# Decision on an application to change consent conditions under the Resource Management Act 1991

Discretionary activity under section 127(3) for Landuse

**Applicant:** Fulton Hogan Land Development Limited

**Site address:** 21 Karapapa Road, Milldale

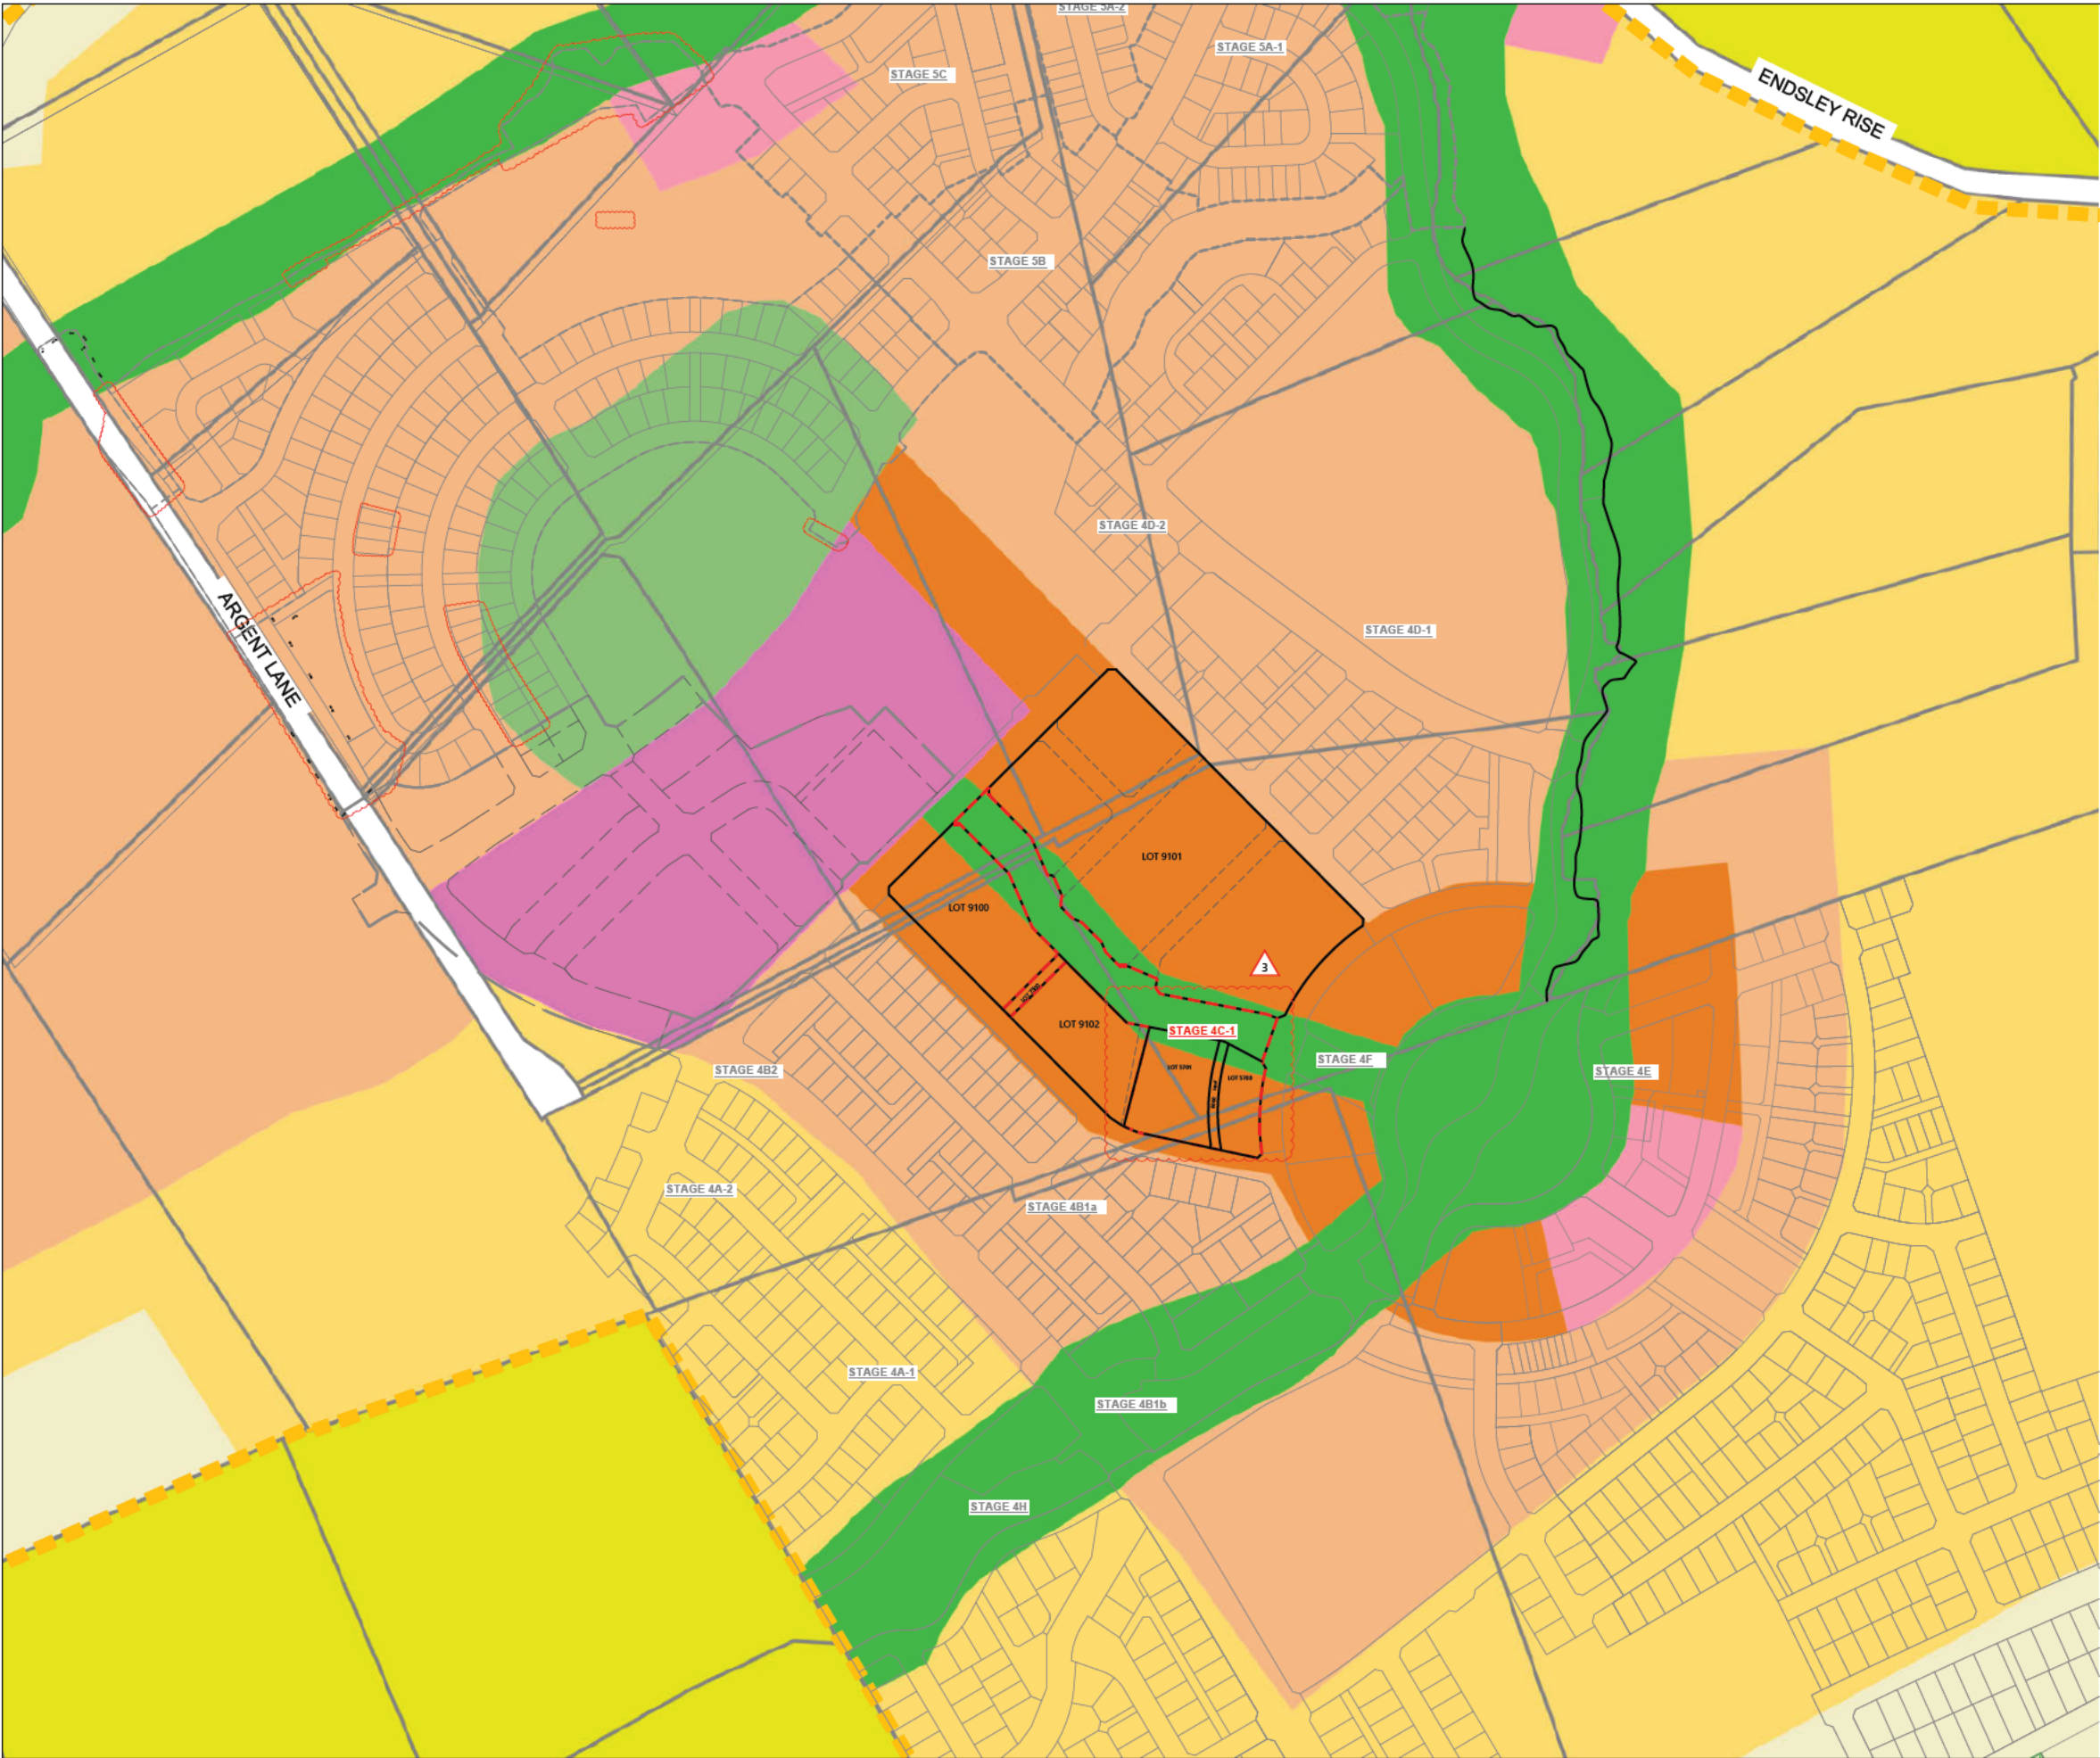
Consent is sought for changes to the approved scheme plan layout to include two superlots (Lot 5700 and 5701) and one Commonly Owned Access Lot (Lot 6000) within approved Lot 5100. This will result in the creation of one additional residential superlot and COAL from what has been consented to.

Creation of super lots 5700 and 5701; and COAL (Lot 6000).

<b>Plan title and reference</b>	<b>Author</b>	<b>Rev</b>	<b>Dated</b>
Survey Scheme Plan 0010-SU	Woods	<u>24</u>	August 2023  <u>Jan. 2024</u>

DETAIL PLAN B  
**JOAL CARRIAGEWAY**  
 1:250 at A3

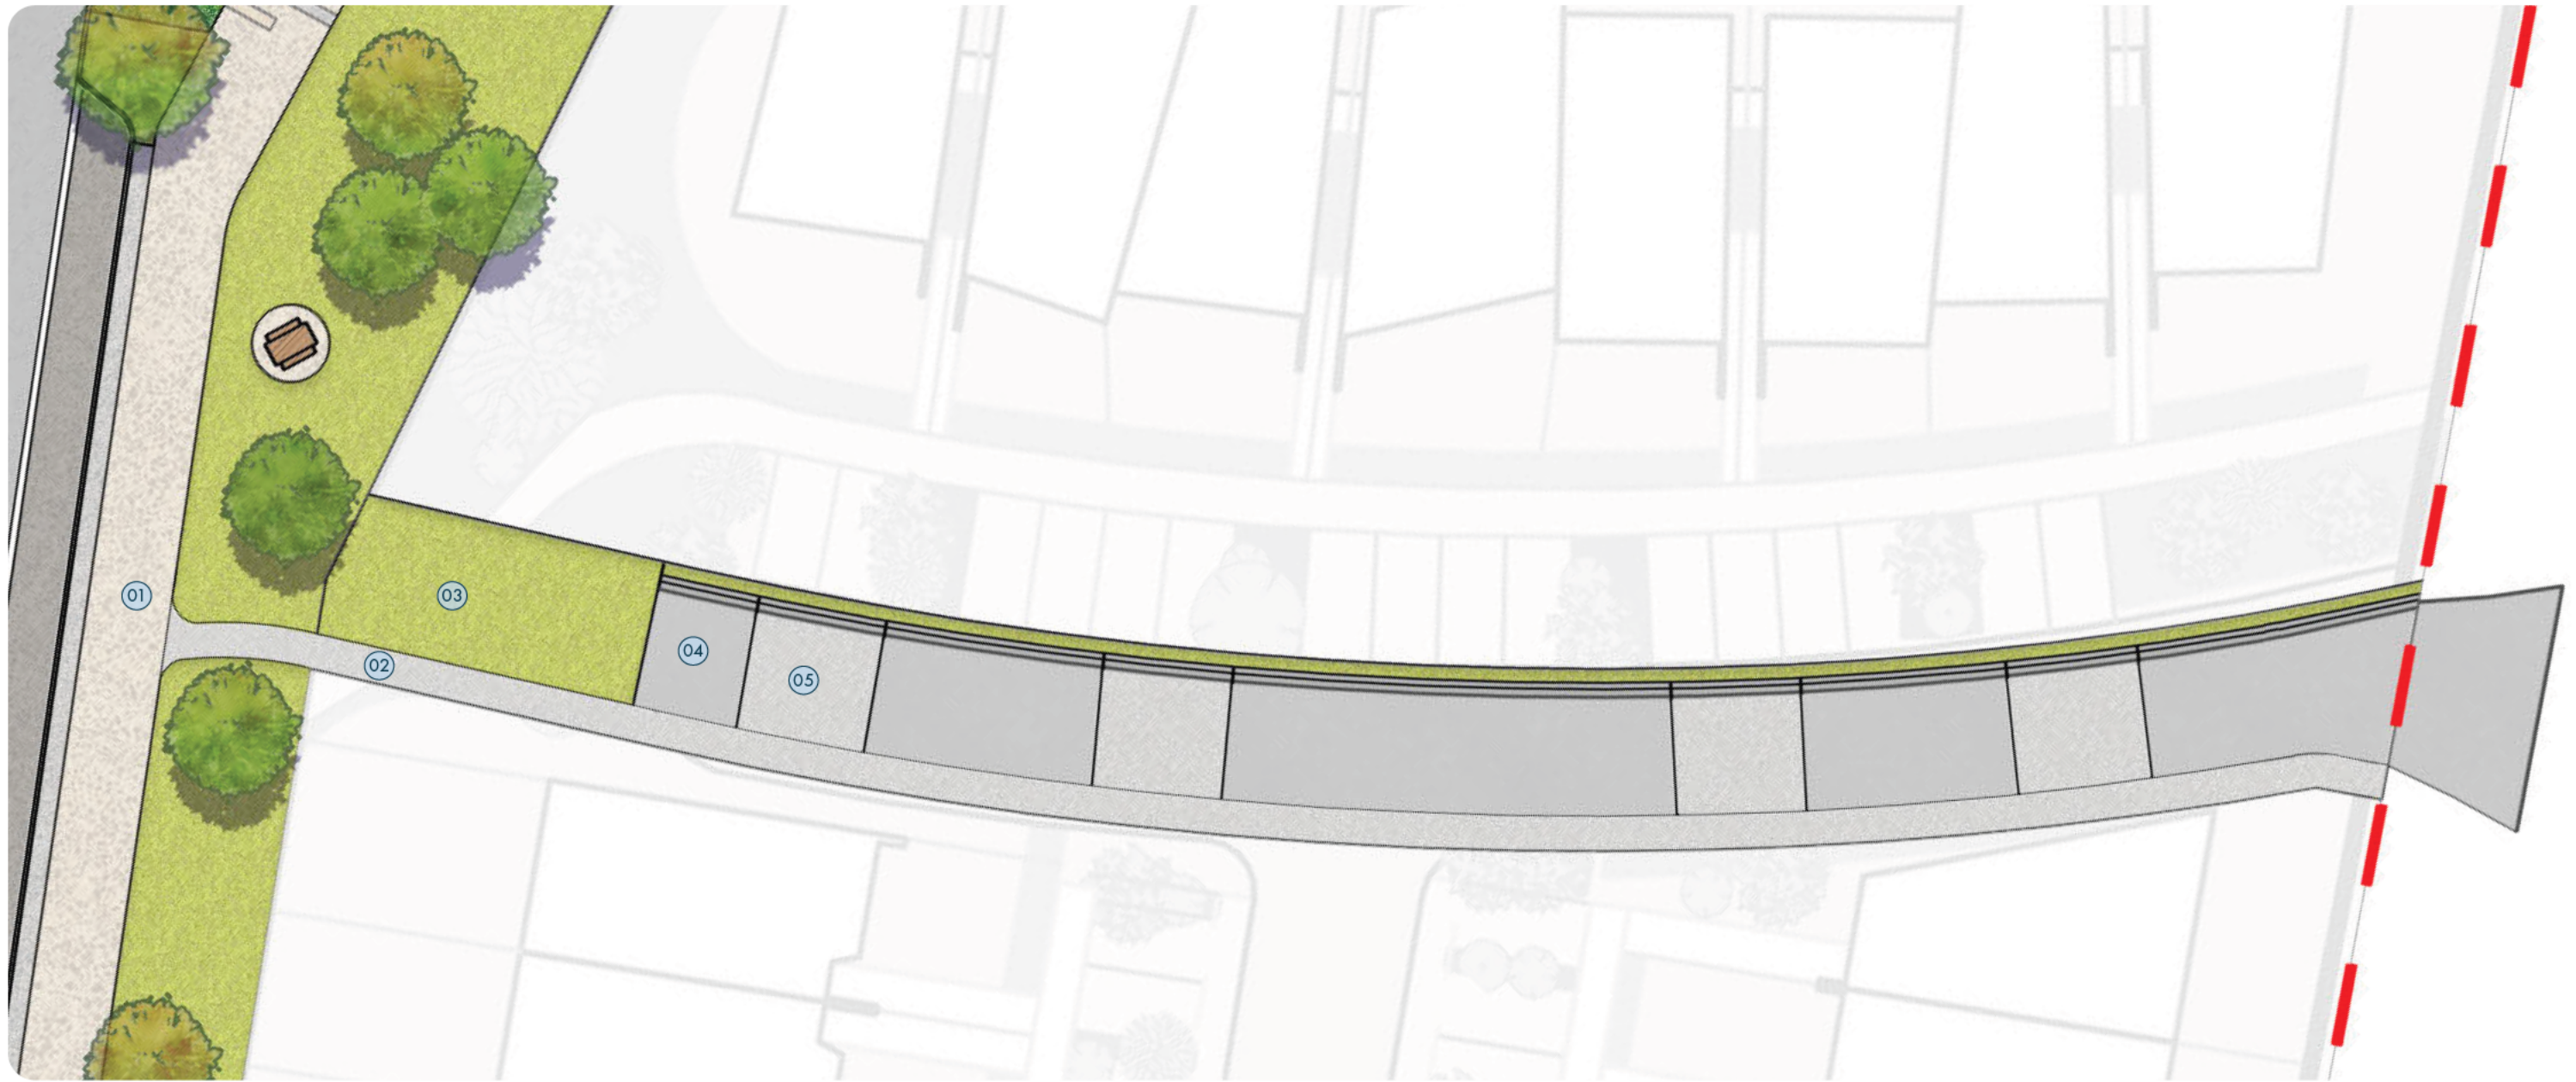
Consent is sought for changes to the approved earthworks extent to enable construction of the proposed JOAL (Lot 6000). The earthworks will involve approximately 1,010m<sup>3</sup> cut and 650m<sup>3</sup> fill over an area of 1.13ha (1,019m<sup>3</sup> cut and 497m<sup>3</sup> fill over an area of 1.13ha approved under [REDACTED]).

- e. The proposed COAL design includes appropriate pedestrian pathways and landscaping that will provide an appropriate level of on-site amenity.
  - f. To ensure that Lots 5700 and 5701 remain adequately serviced and connected, a covenant is proposed by the consent holder to own and be responsible and liable for the ongoing operation of the common accessway, stormwater management device, and landscaping within the Lot 6000 (COAL) area. This has been accepted by the Applicant and now forms part of this consent.
